SUBJECT: **DESIGN-BUILD SERVICES RFP FOR NEW FIRE STATION NO. 63**

Recommend approval of award for change order #1 to ACON Construction Co., Inc., in the amount of $41,185.95, to provide for additional design services needed to address floor plan and exterior design changes requested by JFRD. Total revised guaranteed maximum price not-to-exceed $3,318,135.95.

SUBJECT: CDB-0620-19 – RFP Design/Build Services for New Fire Station No. 63
Acon Construction Co., Inc.

Subject: Summary of Programming Meeting

FIRE STATION NO.63
7300 Gate Parkway, Jacksonville, FL 32256
FLOOR PLAN

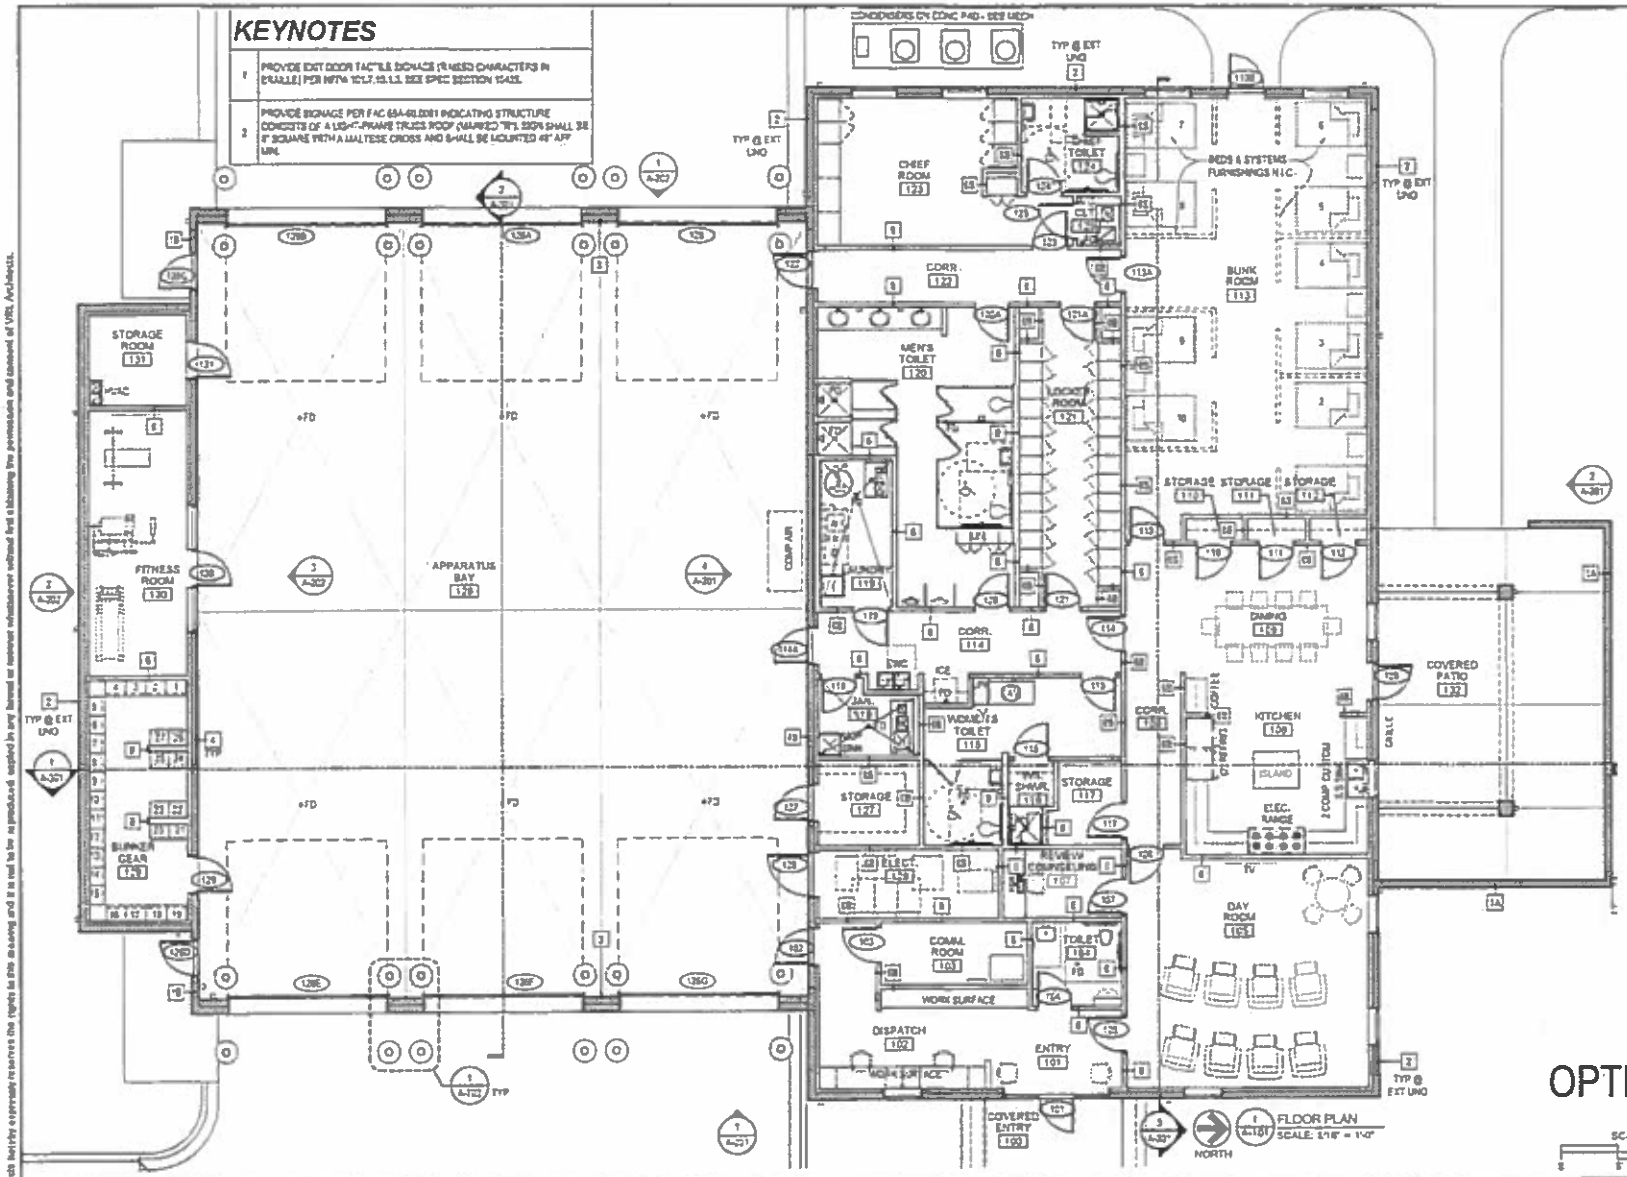
2. Add an Officer's Quarters similar to Fire Station # 73 in place of the Fitness Room and adjacent Storage.

3. Relocate the Fitness and Storage Rooms to the southside of the Apparatus Bays.

4. Provide an "exhaust system drop" to each apparatus bay.

5. Create a common Locker Room with the capacity for 25 lockers. Lockers to be provided with adjustable shelving.

6. Rework Woman's Restroom / Shower Room to provide line-of-sight privacy.

7. Revise the Comm Room to be 10 ft x 10 ft in accordance with the Design Criteria Package.

8. Rework the Supply / Exhaust configuration in the Apparatus Bays in order to preclude positioning a large piece of equipment on the front facing roof.

9. Storage Room # 128 requires conditioning.

10. Replace site built partitions with Owner provided systems furnishings panels in the Bunk Room.

11. City Councilman, Danny Becton, District 11, has requested that the building aesthetic be compatible with the neighborhood environs.
